BC Ambulance Service
BC Emergency Health Services

175-15 Rear Door Garbage BIN MODIFICATION

AMBULANCE TYPE: DEMERS MX151D-BCAS

UNITS AFFECTED: 62800 - 62999

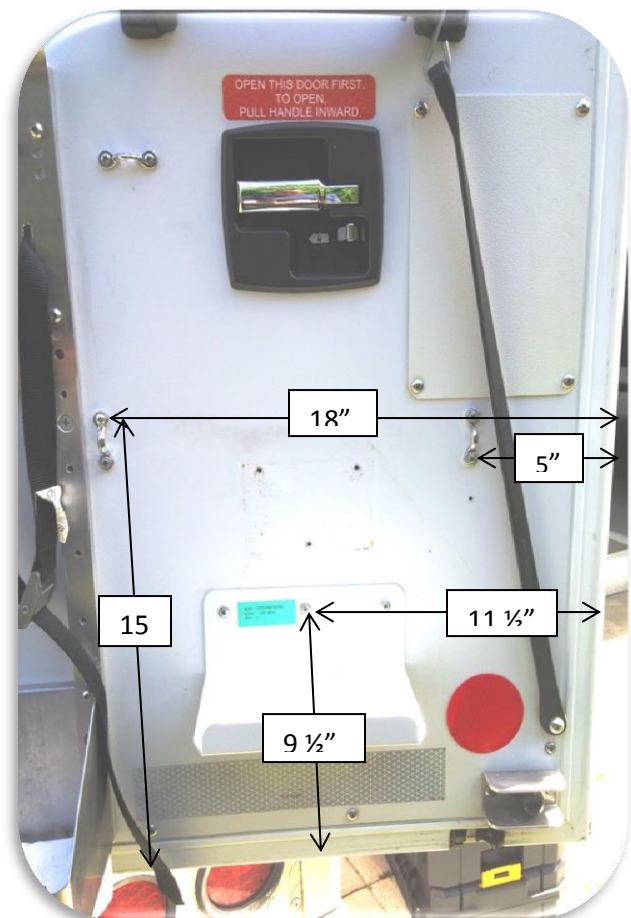
ISSUE: Rear door wire garbage bag holders are failing in service.

ACTION: Replace existing wire bag holder with removable hard shell bin & support shelf

1. Remove old hardware
2. Drill 1/8" holes at locations shown
3. Mount shelf & pad eyes with screws provided
4. Install bin and retaining strap
